ATWS MITIGATING SYSTEM ACTUATION CIRCUITRY (AMSAC)  
RESPONSES TO REQUESTS FOR ADDITIONAL INFORMATION

POWER AUTHORITY OF THE STATE OF NEW YORK  
INDIAN POINT 3 NUCLEAR POWER PLANT  
DOCKET NO. 50-286  
JANUARY 11, 1982

<b>S</b> SAFETY RELATED ITEM		1	7/2/81	FOR INQUIRY	
		2	8/2/81	FIRST ISSUE FOR INQUIRY	
		3		DATE	DESCRIPTION
		ENGINEER: <i>Richard W. La...</i> STATE REG. NEW YORK NO. 45172			
		ATWS MITIGATING SYSTEMS ACTUATION CIRCUITRY (AMSAC) LOGIC DIAGRAM			
		SCALE: NONE 0606 210-D-1

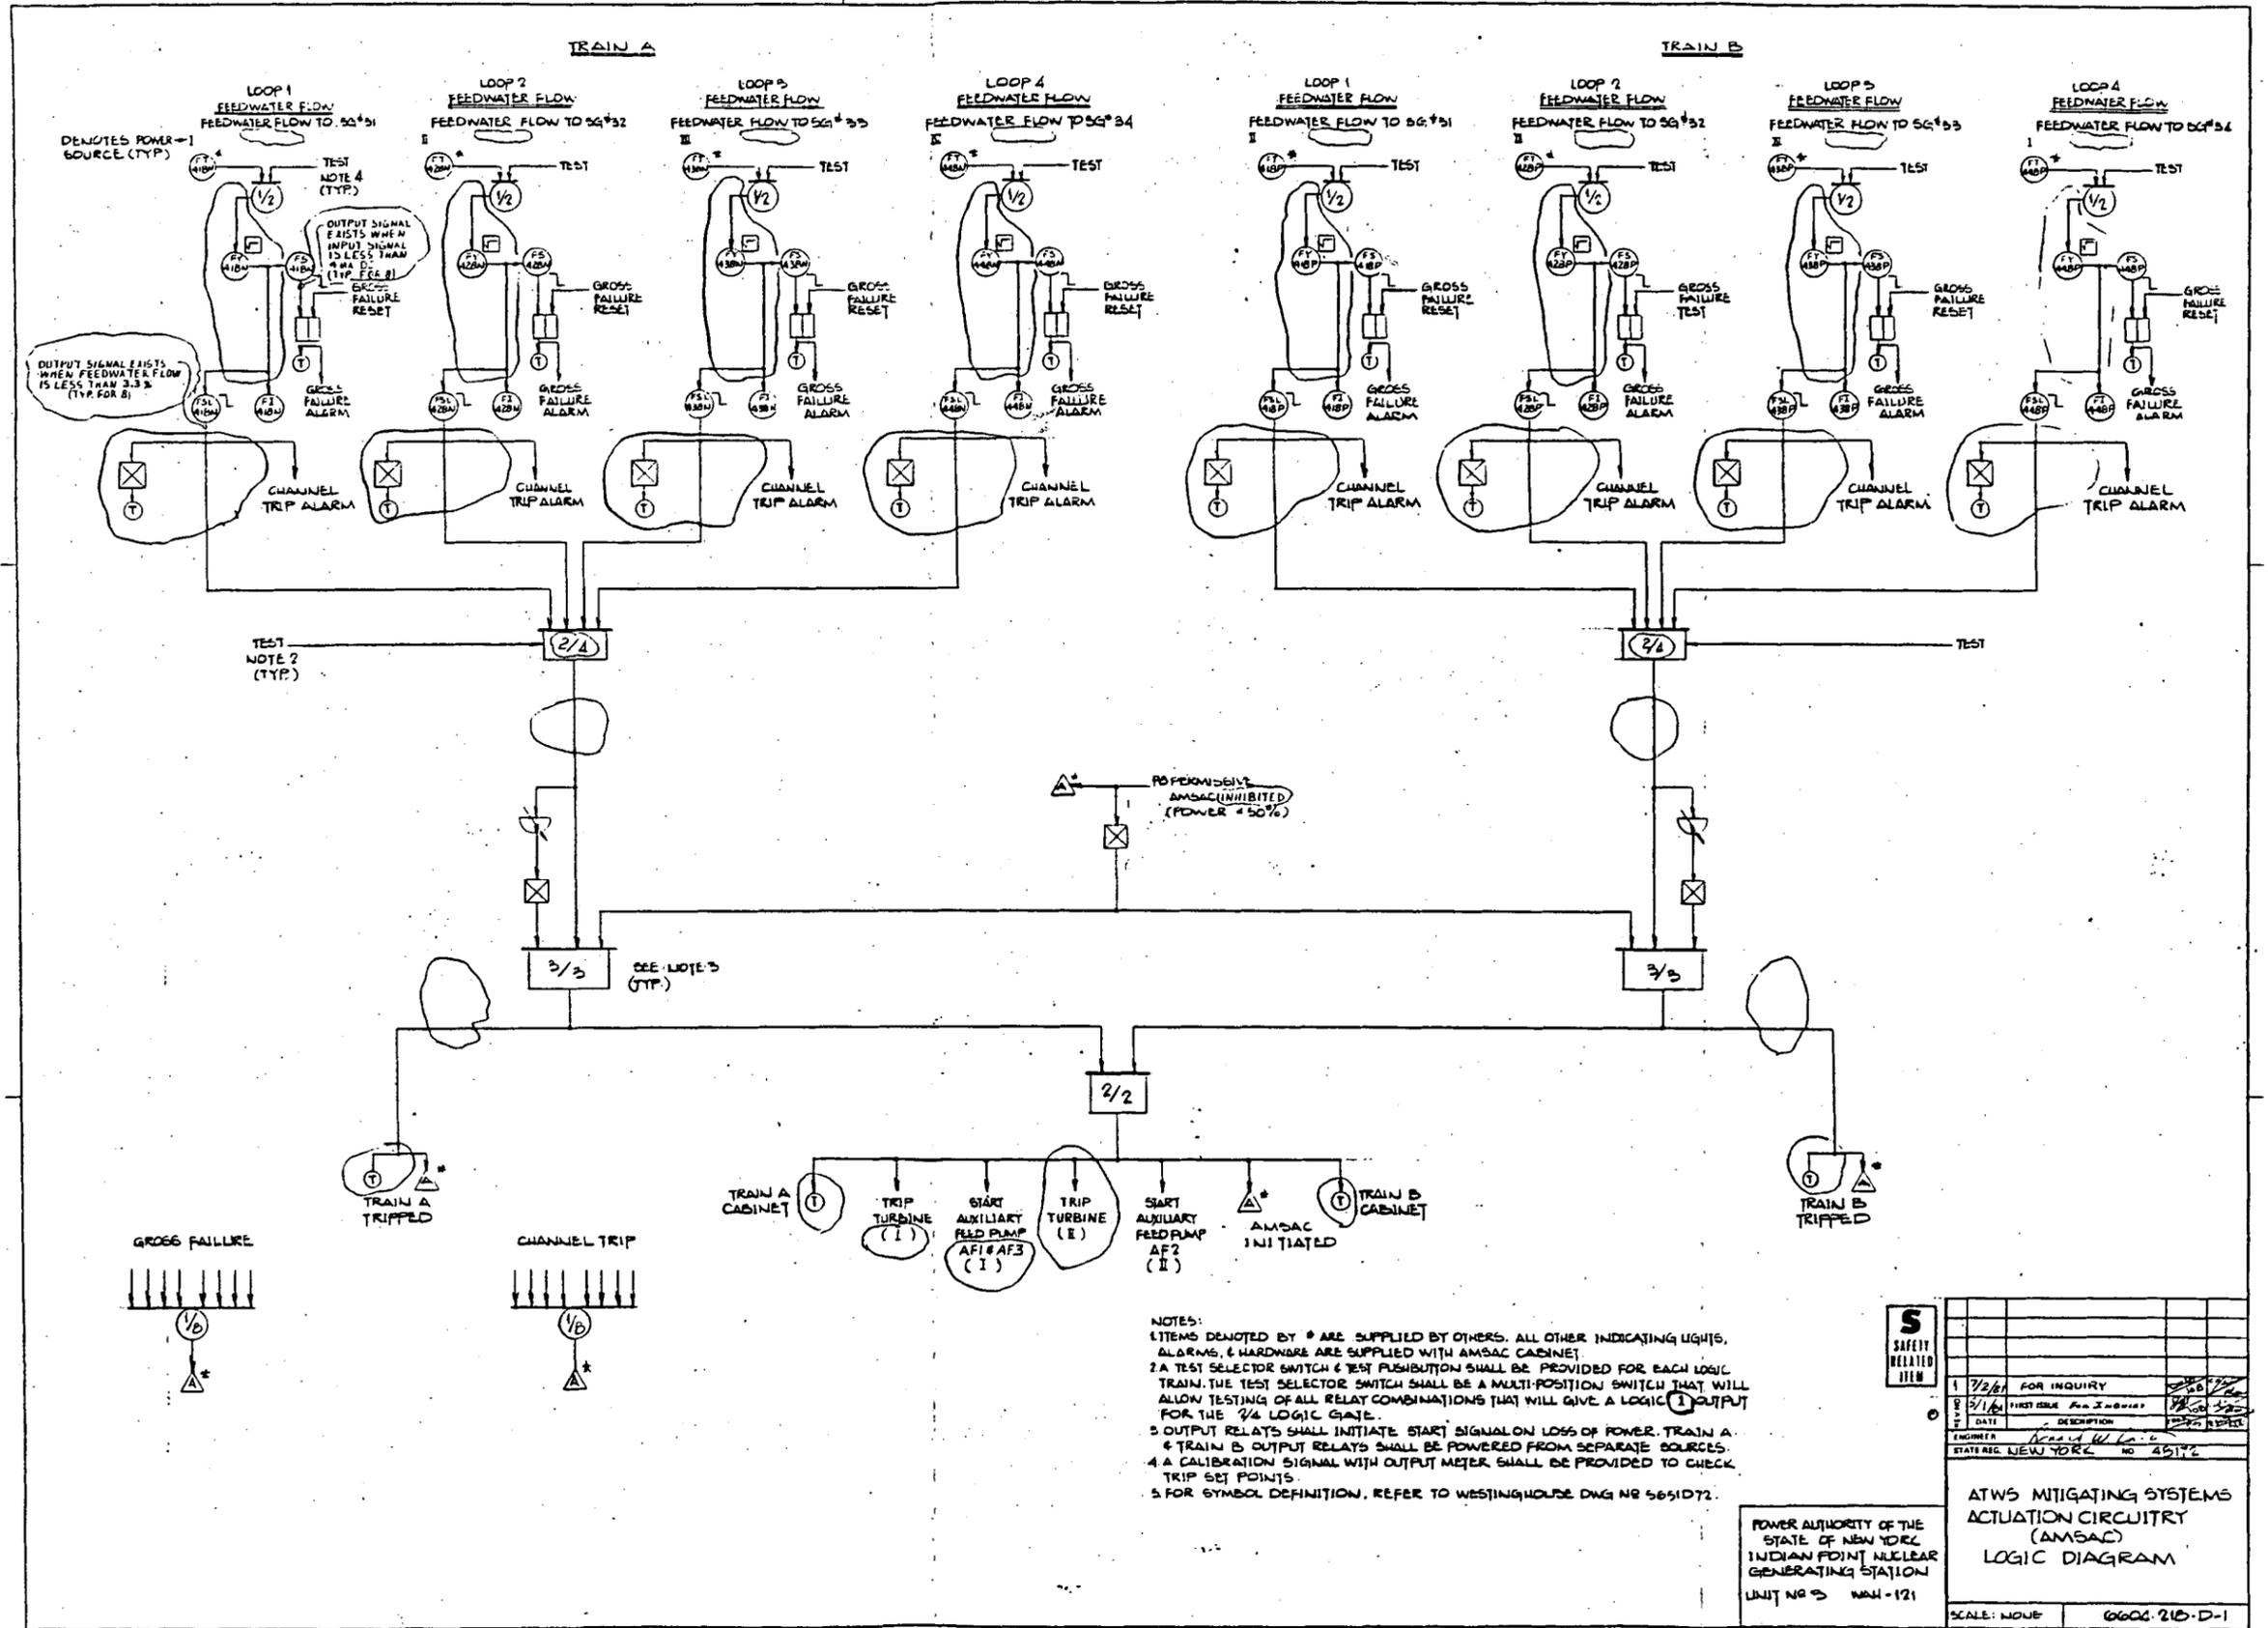
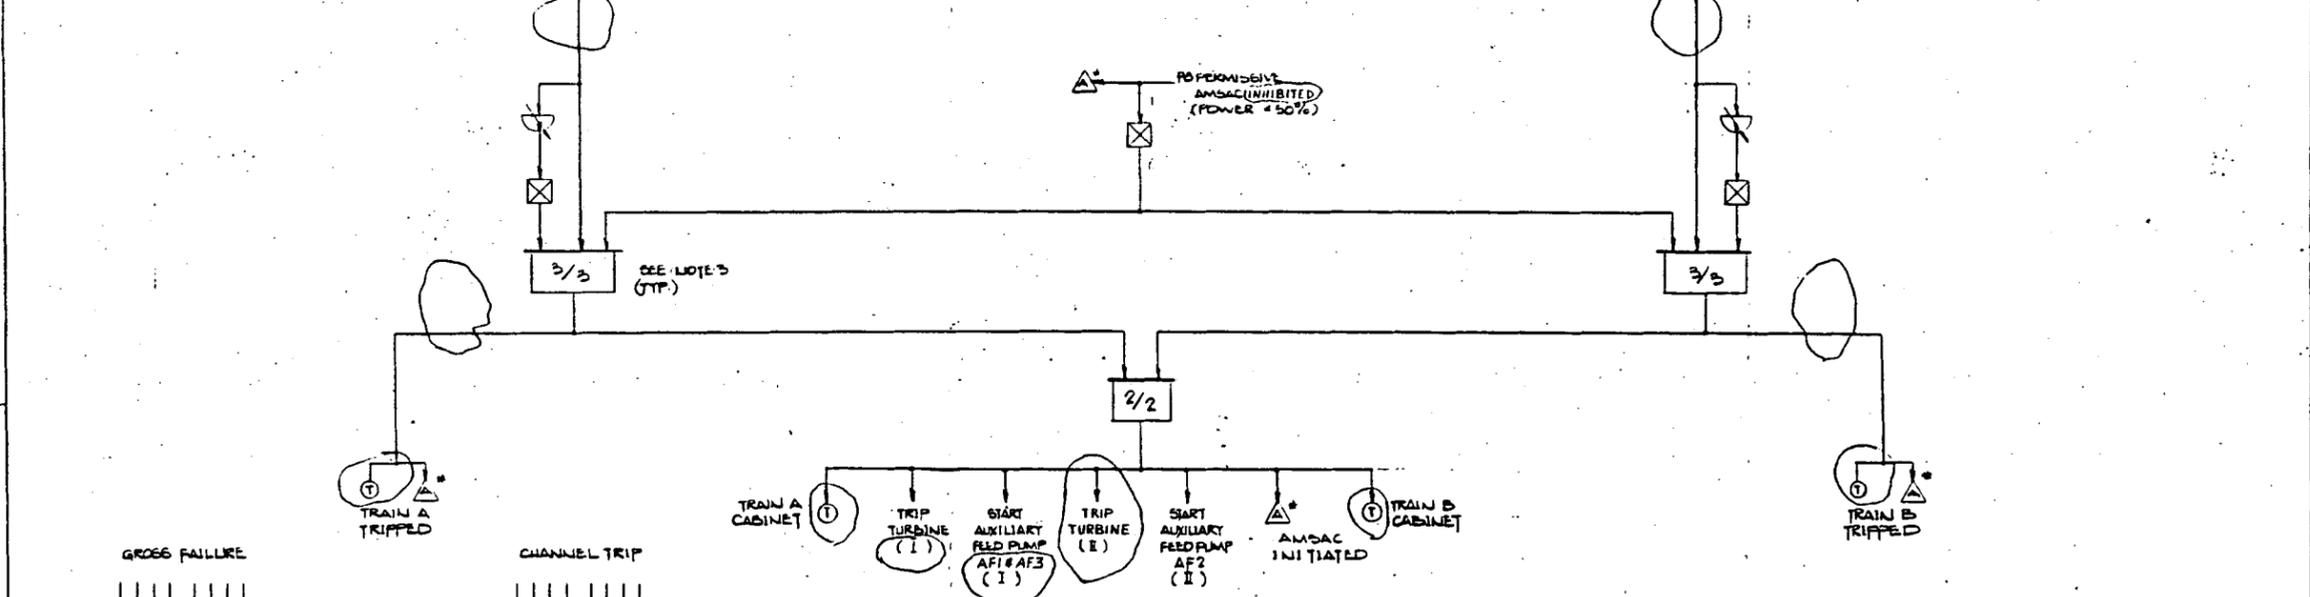
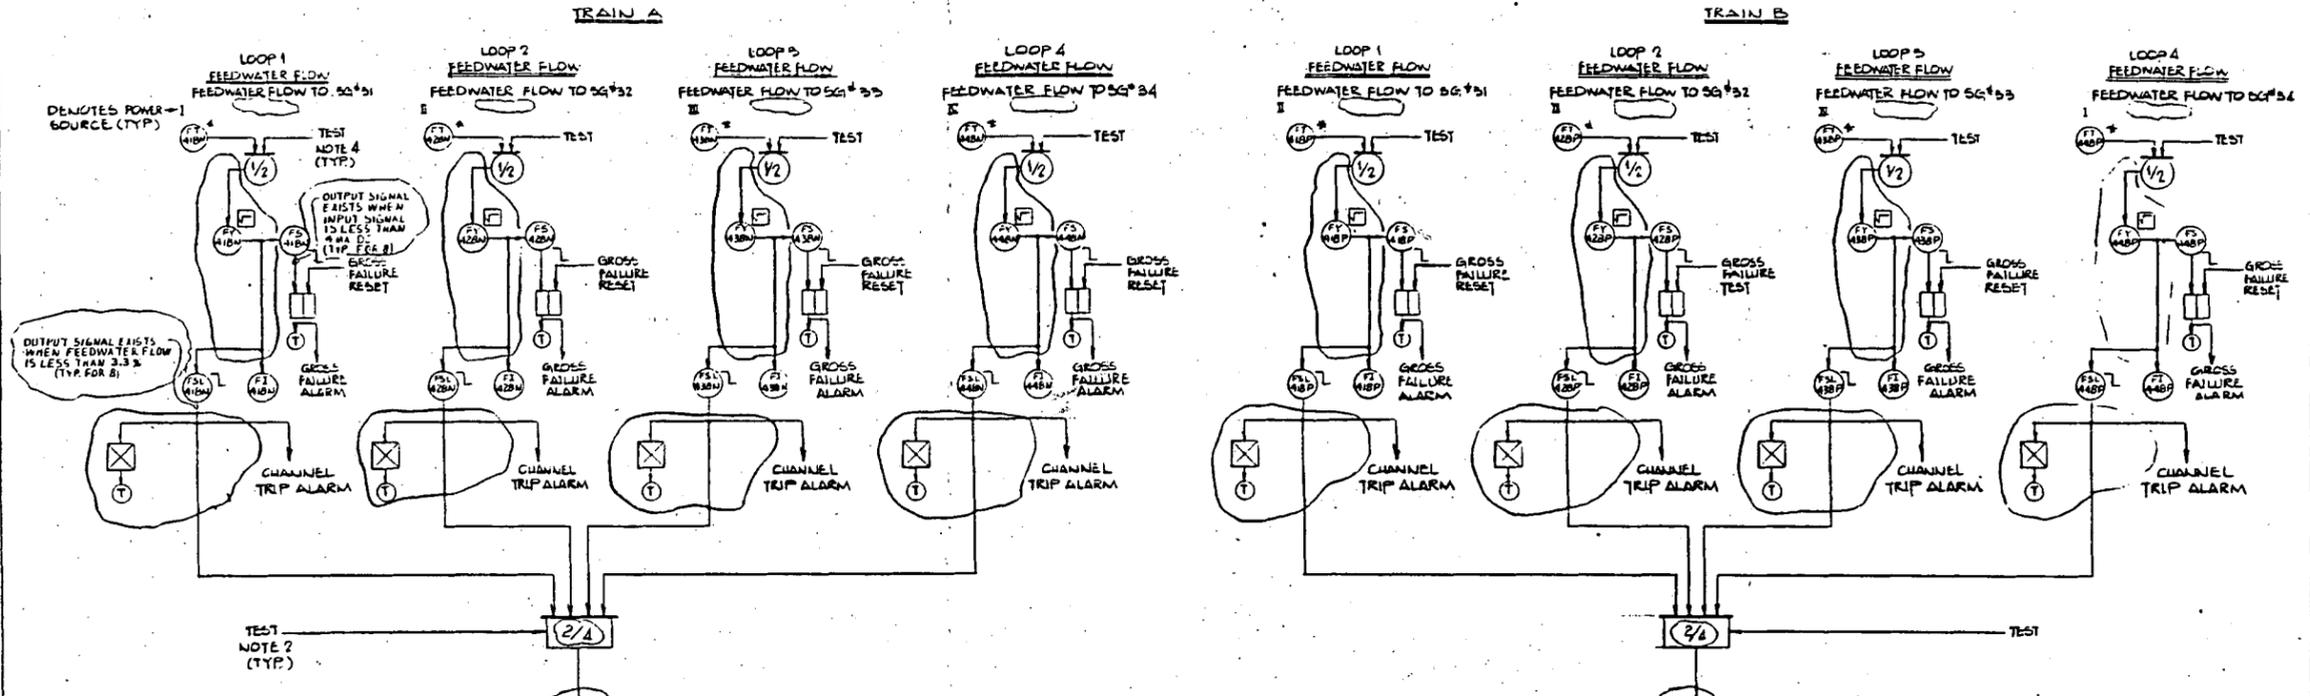
5. Discuss the independence (physical separation and electrical isolation) provided between AMSAC actuation channels.

9. Provide elementary schematic/wiring diagrams for the Indian Point Unit 3 AMSAC showing:

- a. initiation circuits
- b. annunciation/indication circuits
- c. permissive (50% power)
- d. any manual overrides/resets

AMSAC consists of two independent, separated and redundant actuation channels. Separate sensors (transmitters) and logic cabinets are dedicated to each channel. The two channels are brought together in the final 2 out of 2 gate (refer to attached sketch) that initiates the actuation circuitry. The coincidence is provided to prevent spurious tripping of the plant since both AMSAC channels actuate on loss of power.

Since the final design has not yet been completed, the above drawings are not available for submittal. The AMSAC Logic Diagram, however, has been finalized and it has been attached for your review.
